NRL Report No. B-2054

Report of Test

Switches, Multipole Rotary

Arrow-Hart and Hegeman Electric Company

PLATE 4

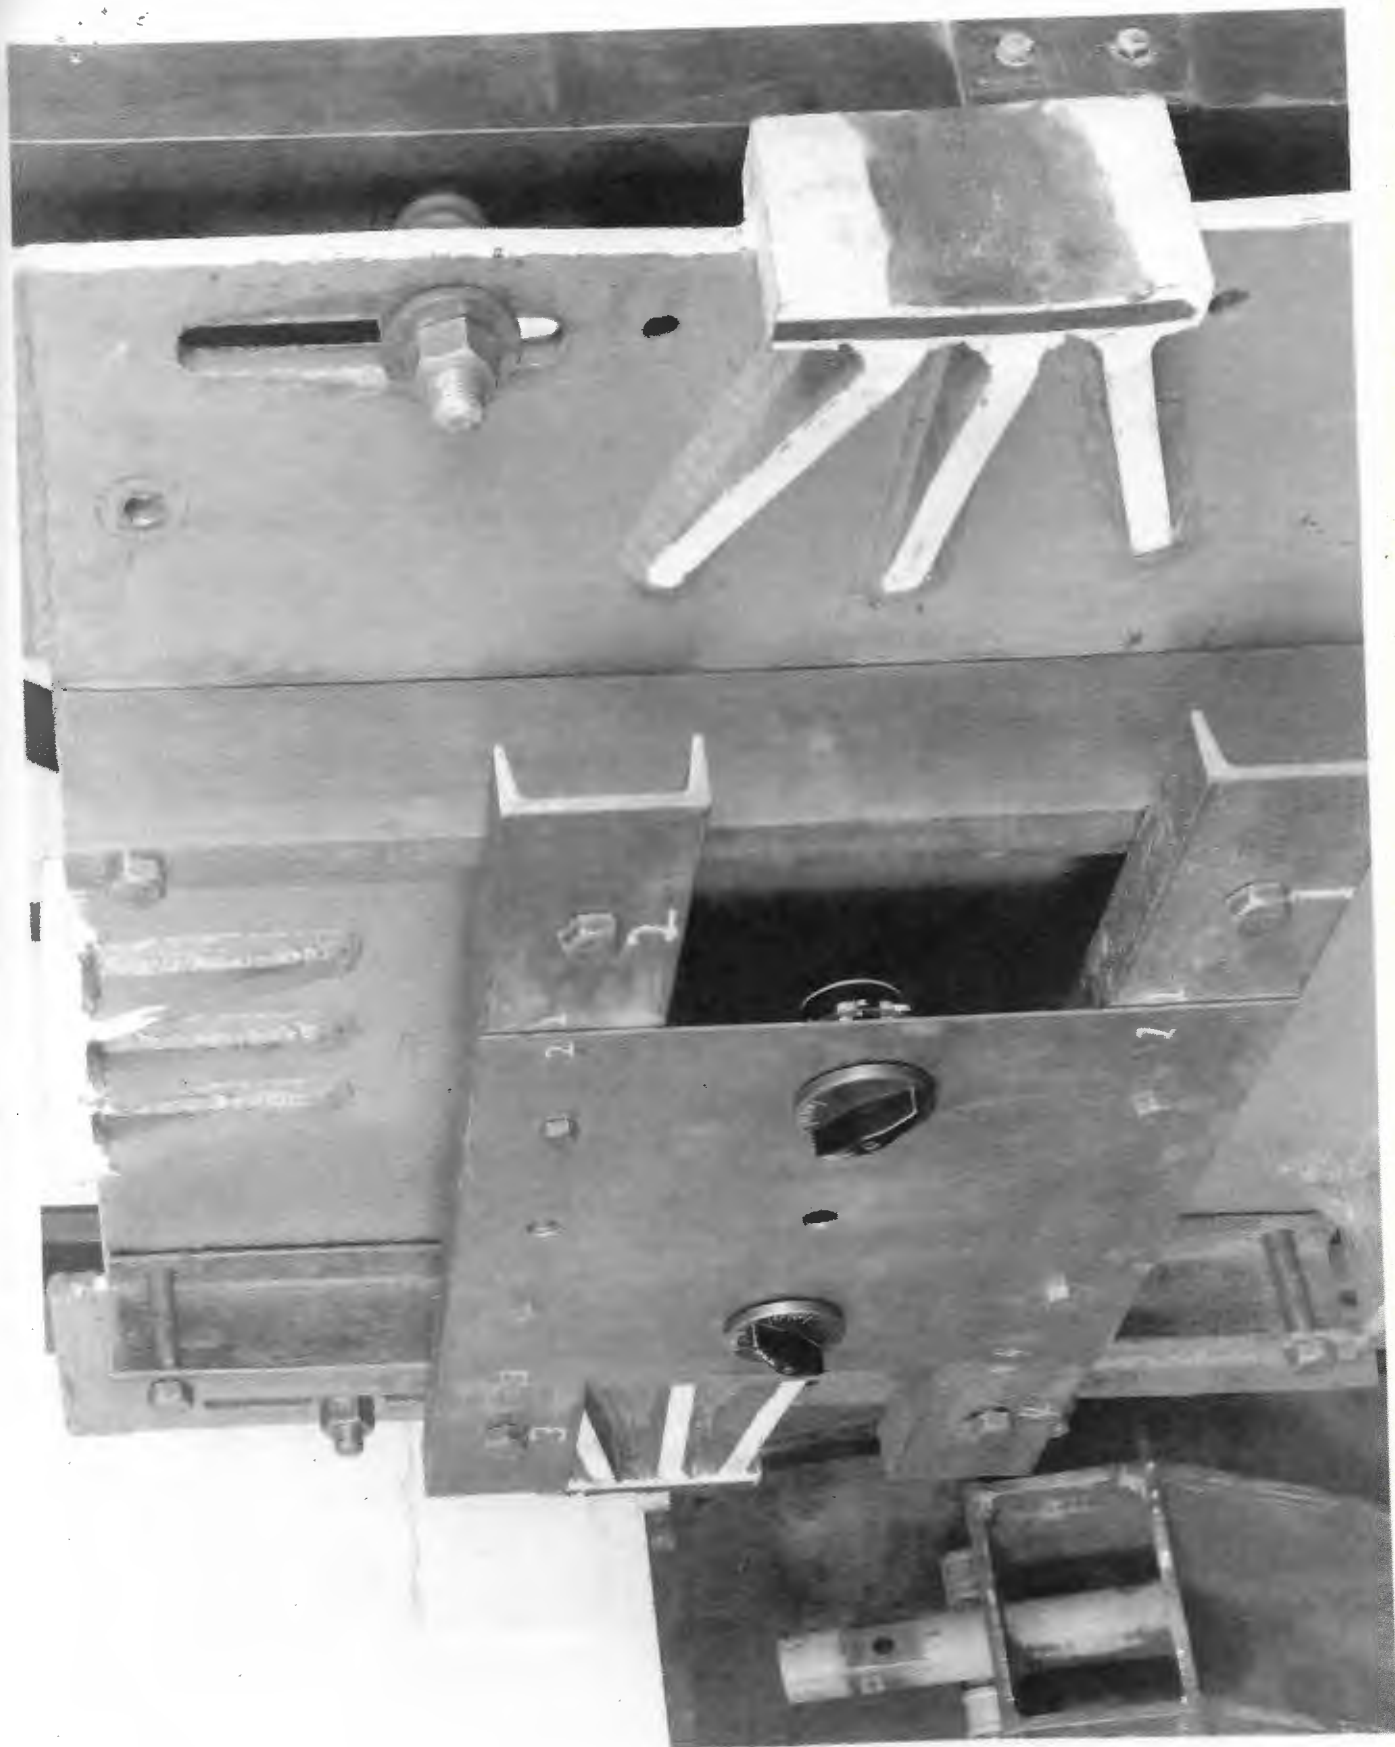
13. The HI shock test resulted in no apparent damage to the switches except that in the switch having a removable shaft the collar securing the shaft extending through the back plate came off, allowing the shaft to be partially ejected. The average drop across the fixed contact terminals when the switches were carrying rated load, was 52 millivolts before and 56 millivolts following the test.

15. The results of the HI shock test indicate that the strength of the switches is adequate to withstand high impact shock except that in the switch having a removable shaft, a better method of securing the collars to the shaft should be provided.

(c) That the switch having a removable shaft be considered to have satisfactory HI shock resistance subject to the adequate securing of the shaft collars.
